705 Magnolia Ave screen dryer vent

Subject: Re: 705 magnolia ave screen for dryer vent

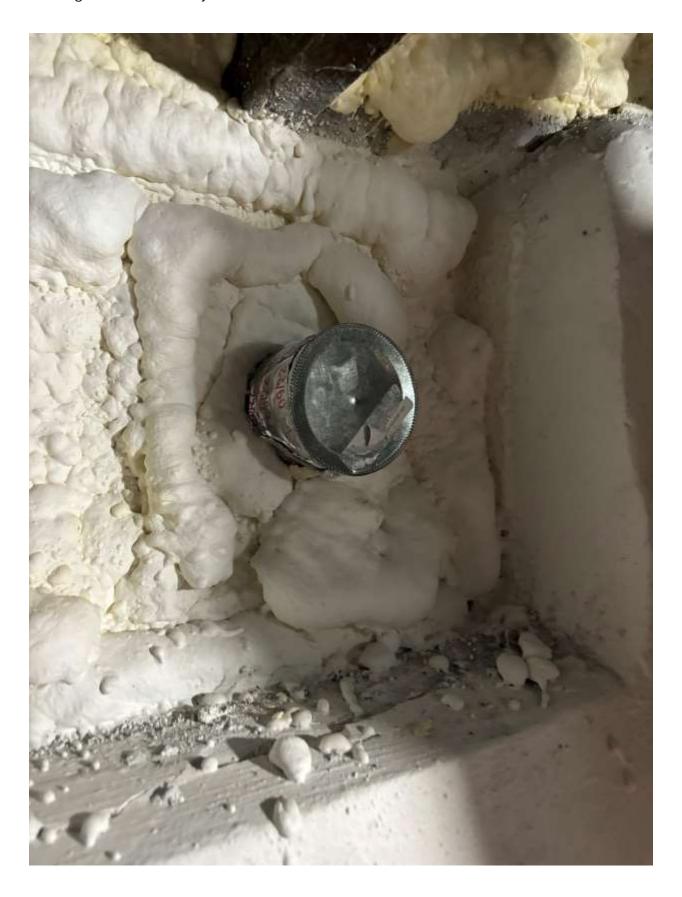
From the photos I do not see any supports on the combustion air duct. Also it's a little hard to tell what I am looking at in the last two photos, if that is the dryer vent hood the screen and plastic cover need to be removed
